# Instrument Panel Rattle

YEAR(S)	MODEL(S)	ADDITIONAL INFORMATION
2006 – 2007	IS250, IS350

### TSB SUPERSESSION NOTICE

The information contained in this TSB supersedes TSB No. NV003–06.

Figure 1.

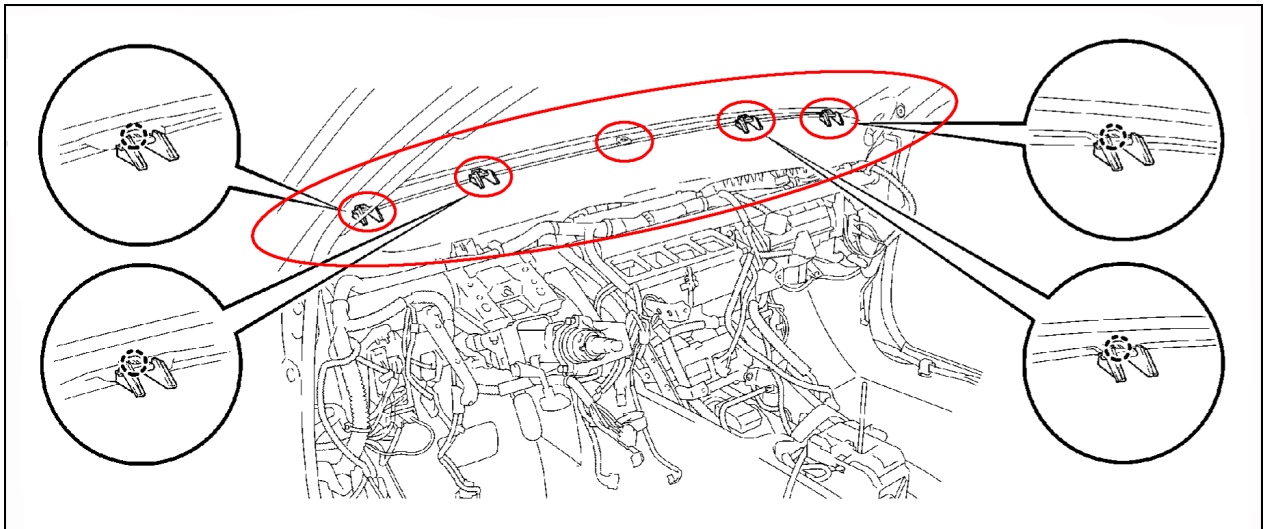
3. Remove the instrument panel clip (Stay No. 3) at the center of the dash and replace with the NEW clip. Repeat the same on the remaining four clips (instrument panel clip No. 1).

**Figure 2.**

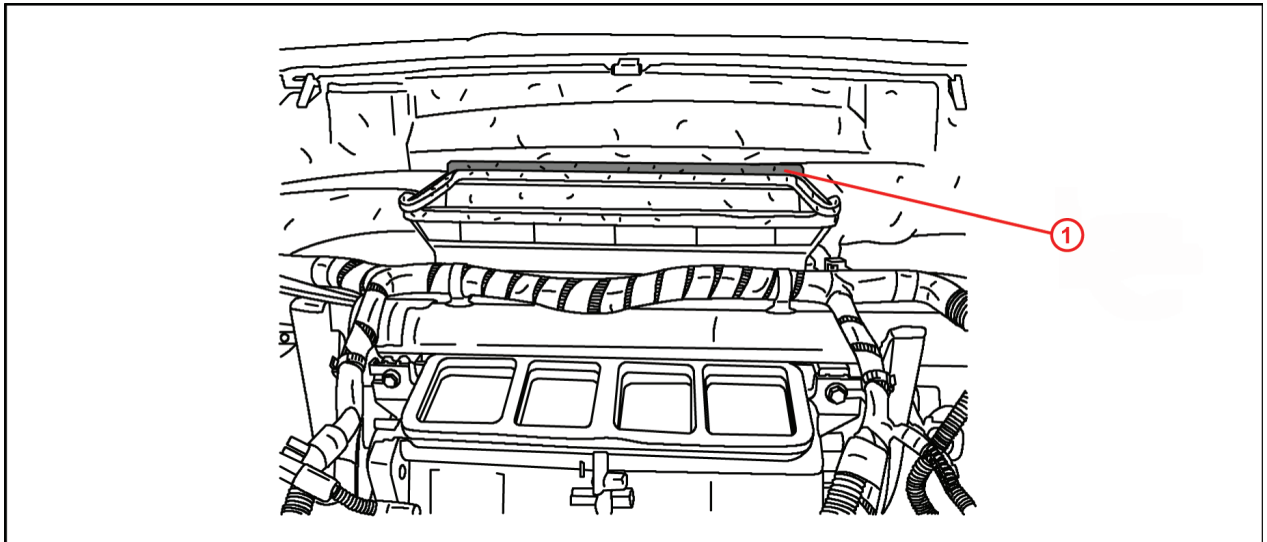
4. Apply felt along the defroster nozzle lip as shown in Figure 2.

**Felt Size**

**Length:** 29 cm (11.42 in.)

**Width:** 14 mm (0.55 in.)

**Thickness:** 0.5 mm (0.02 in.)

<b>1</b>	Apply felt (as necessary) in this area if the urethane foam is worn away or if there is plastic to plastic contact between components.
----------	--

Figure 3.

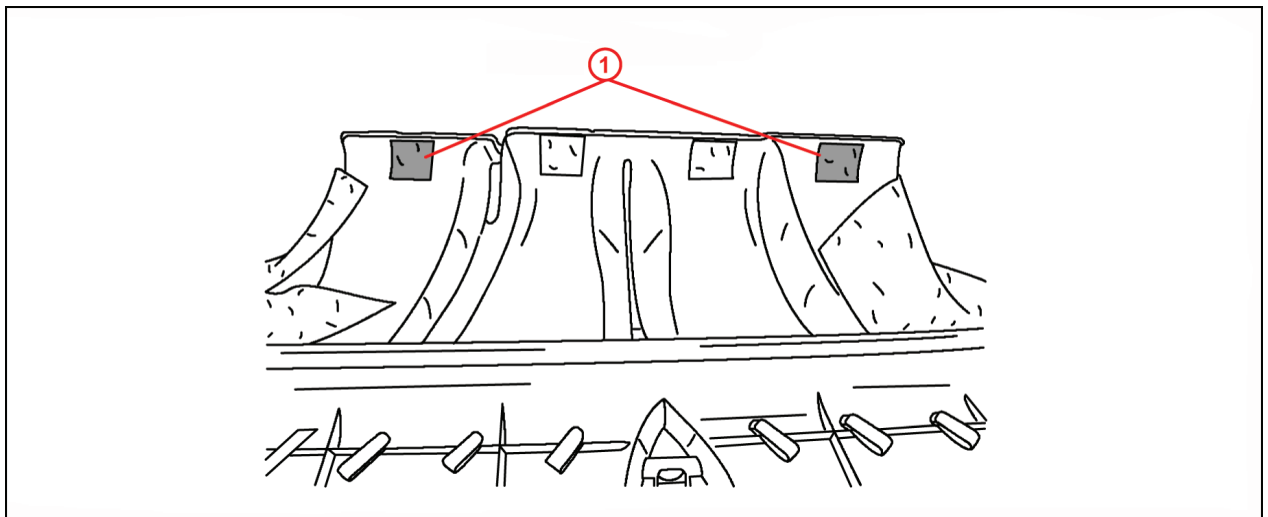
5. Apply foam to the instrument pad HVAC duct as shown in the following illustration.

**Foam Size:**

**Length:** 30 mm (1.18 in.)

**Width:** 30 mm(1.18 in.)

**Thickness:** 5 mm (0.20 in.)

**1** Apply foam here
